**AN APPLICATION
FOR A MODIFICATION TO AN
APPROVED PLANNED UNIT DEVELOPMENT**

**AT PREMISES
2501 WISCONSIN, NW
SQUARE 1935, LOT 817**

**FOR
ST. LUKE'S CONDOMINIUMS, LLC**

**STATEMENT OF ST. LUKE'S CONDOMINIUMS, LLC FOR A MODIFICATION OF
AN APPROVED PLANNED UNIT DEVELOPMENT**

Partial Elevation / Typical Facade

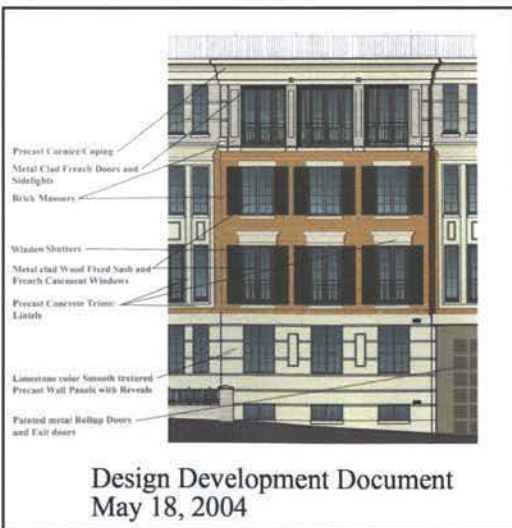
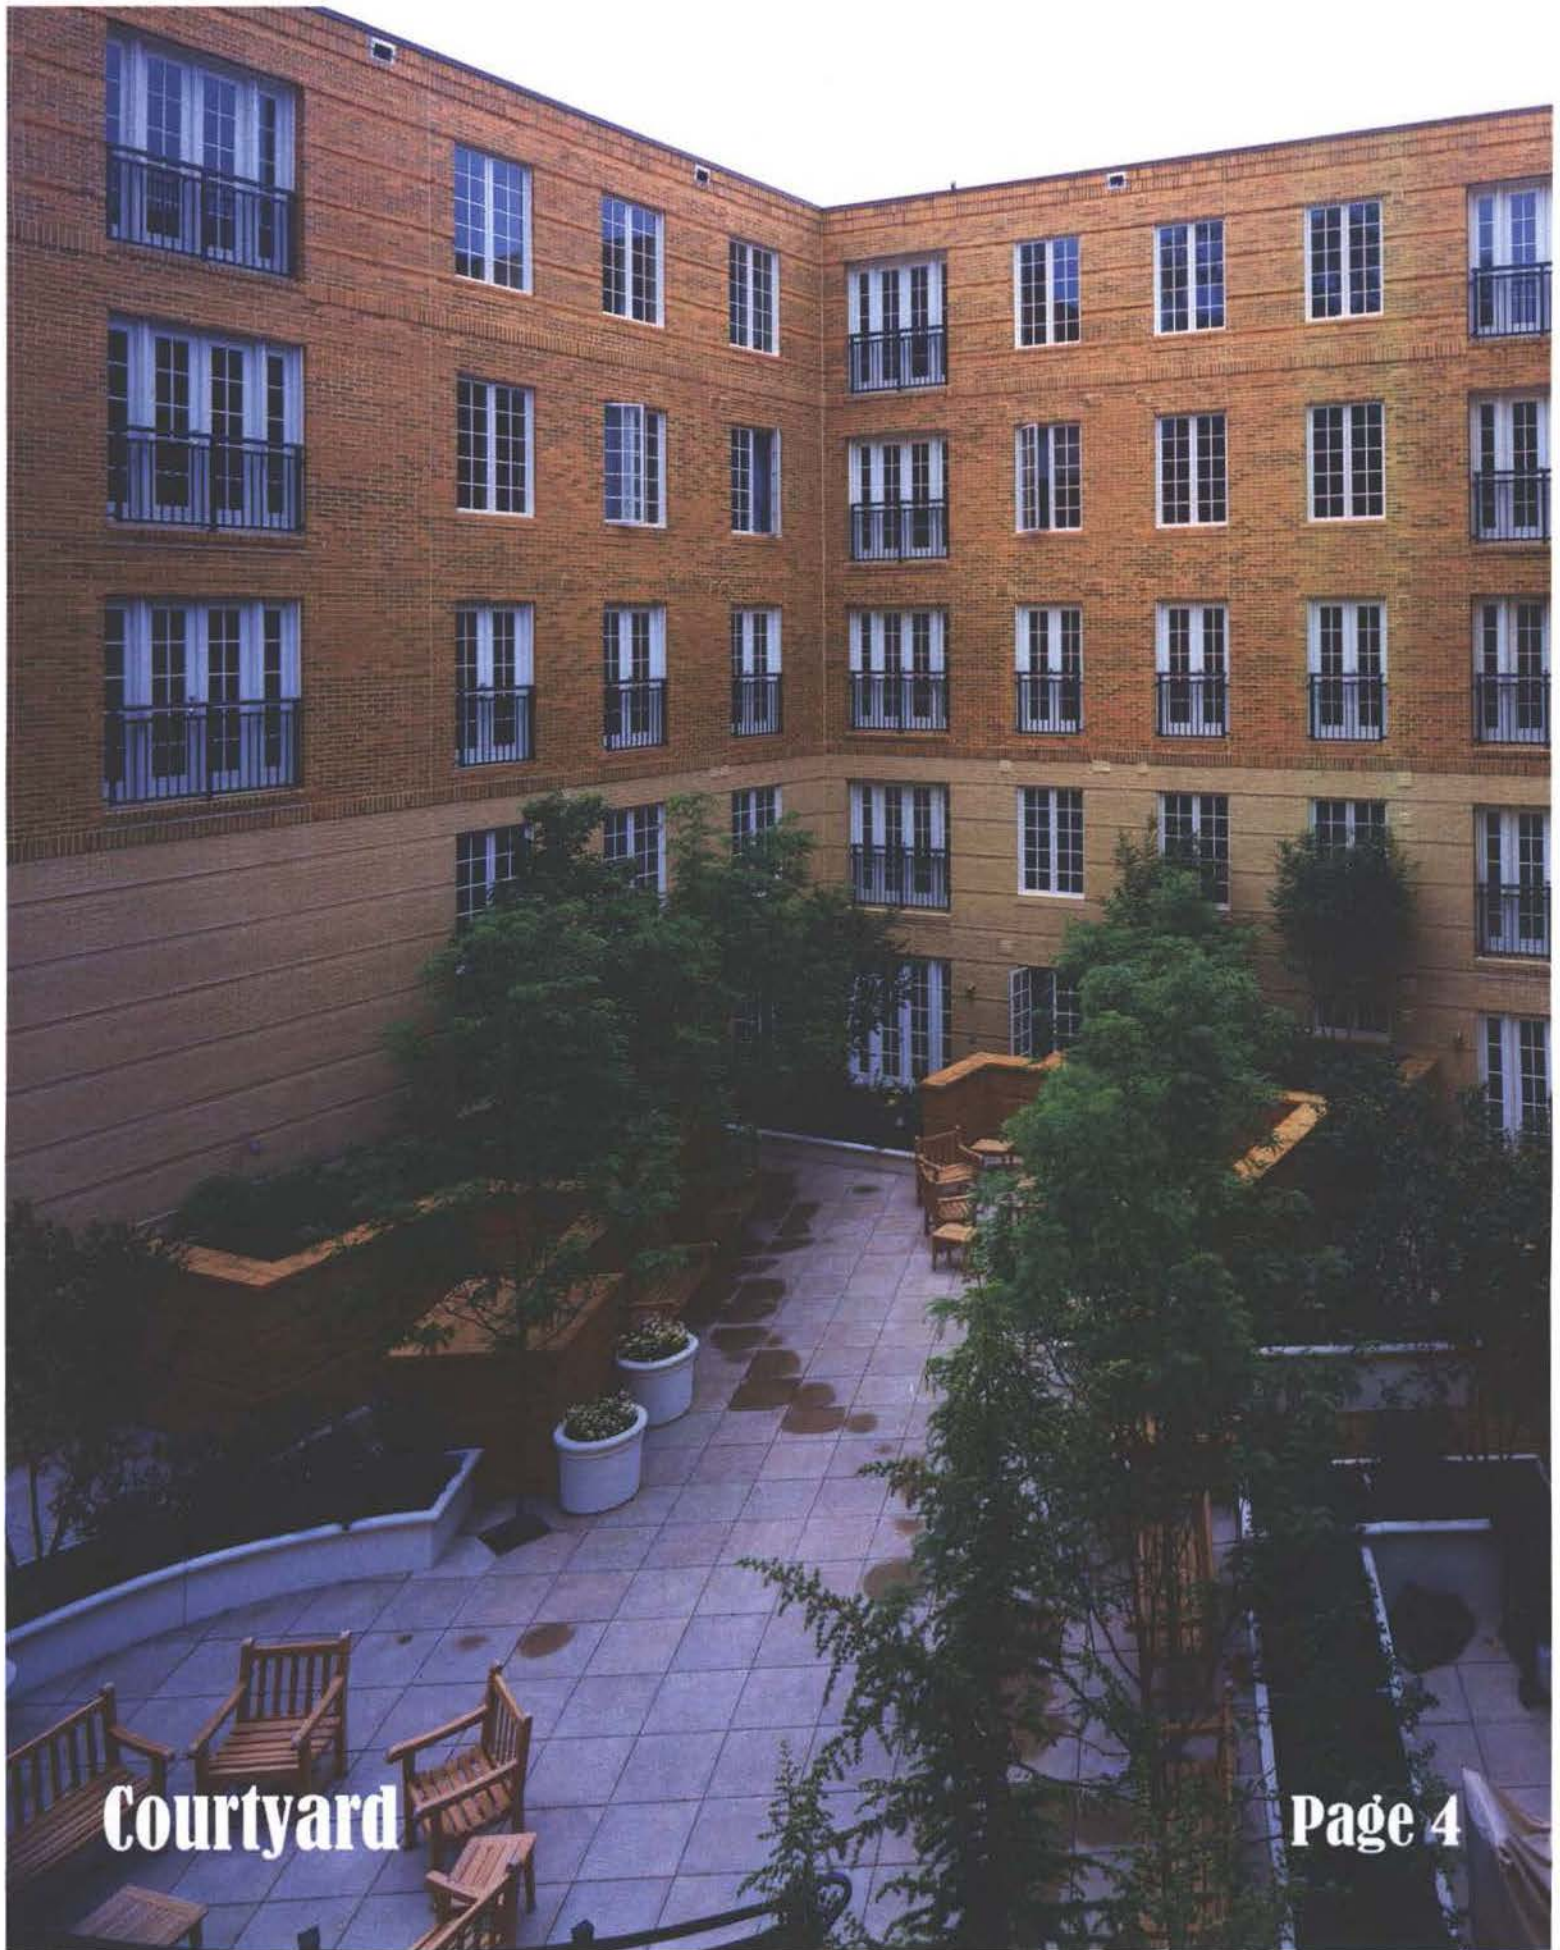
1. Primary Façade. The single primary façade of the Original PUD was modified into two distinct facades - a primary and a secondary façade. On the third floor, the primary façade was constructed with a quadruple casement window configuration in lieu of the arched window shown in the Original PUD. As this area of the building is important to the rhythm of the structure, additional precast elements (beyond what was originally proposed) were added to

the second and third floors to maintain the façade and fenestration. Above this element, quadruple casement windows were provided rather than a balcony feature as the final design for the units incorporated interior spaces with in-swinging balcony doors which would have compromised the usability of the residential space. On the fourth floor, complementary buff brick masonry was constructed in lieu of the proposed precast pilasters. Additionally, precast sills and painted aluminum railings were constructed in lieu of the precast brackets for the fourth floor balconies. The railings were painted the same color as the mansard detail and the shutters, and serve to provide safety, definition, and continuity to the façade. (See pages 2-3 of Exhibit B).

View of Existing Roof Structure

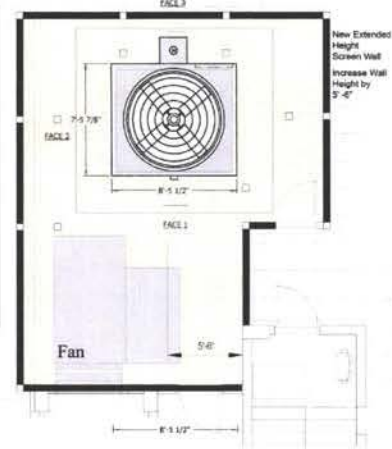
3. Masonry Finish on the Mechanical Penthouse Structures. The plan details for the Original PUD called for a masonry finish on the mechanical penthouse structure. The Applicant believes that the application of a masonry finish to the roof structure will highlight the roof structure to a degree that detracts from the overall appearance of the building. The Applicant believes that the existing color of the roof structure matches the surrounding precast elements and helps mask the overall appearance of the roof structure. For these reasons, the Applicant did not apply a masonry finish to the mechanical penthouse roof structure.

Rooftop Cooling Tower Screening

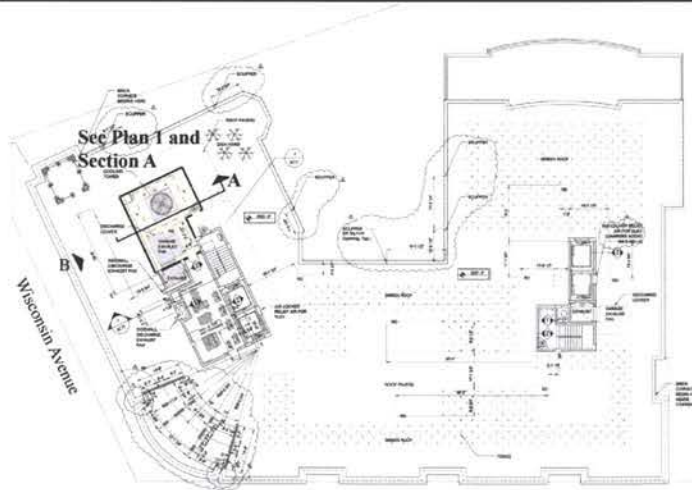
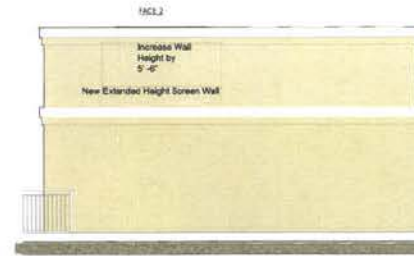
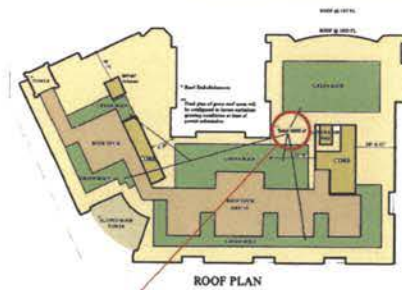
1. Cooling Tower. At the time of PUD approval, it was the intention of the Applicant to use individual condenser units to heat and cool each condominium unit. Upon

further engineering analysis the decision was made to implement a water source heat pump system that relies on a cooling tower to manage temperature through the water loop system. This is a more expensive system from a construction installation perspective, however it is anticipated that it will provide the condominium owners with lower maintenance costs over time and ultimately better performance. Central systems are more efficient to operate, have fewer components (i.e., lower embodied energy), and last much longer. Central systems are considered to be a superior choice from a “green” design perspective. For these reasons, the project’s central system provides significantly greater environmental benefits than the split system provided in the Original PUD.

The result of the decision to use a different heating and cooling system is that a cooling tower was required to be placed on the roof of the building. The inclusion of a cooling tower on the roof required a reconfiguration of the structures on the roof. The cooling tower selected by the Applicant has a small footprint which minimized the degree to which the overall footprint of the penthouse had to grow to accommodate the water source system. However, in order for water to gravity flow through the cooling tower, the cooling tower had to be placed on several pedestals that are approximately 48 inches above the surface of the roof. Thus, the top of the cooling tower protrudes above the penthouse wall by approximately 5 feet, 6 inches (See page 7 of Exhibit B). In order to minimize the visibility of the cooling tower, the Applicant has painted it to match the color of the penthouse exterior. Based on discussions with the Office of Planning, the Applicant proposes to enclose the cooling tower in the existing roof structure. As shown on page 8 of Exhibit B, the revised roof structure will have a height of only 16 feet.

Comparison of Green Roof
PUD Submission, Design and Construction

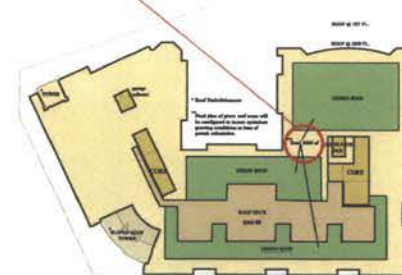
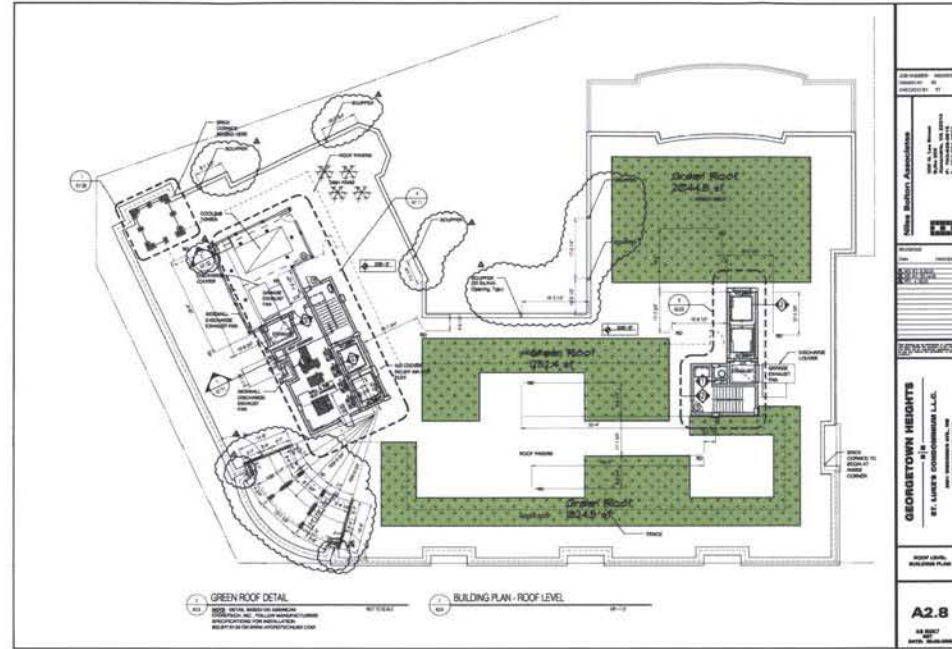
2. Location of the Roof Structures and Configuration of Green Roof – As shown on page 9 of Exhibit B, the roof structures and configuration of the green roof element are different

than the Original PUD. As the roof structures moved, the other elements on the roof also needed to be modified. The final configuration of all the elements on the roof actually increased the size of the “green roof” element to 5,127 square feet (compared to the Original PUD’s requirement of a 5,000 square foot “green roof”), allowed for easier maintenance of the “green roof” components, and created a more efficient roof deck.
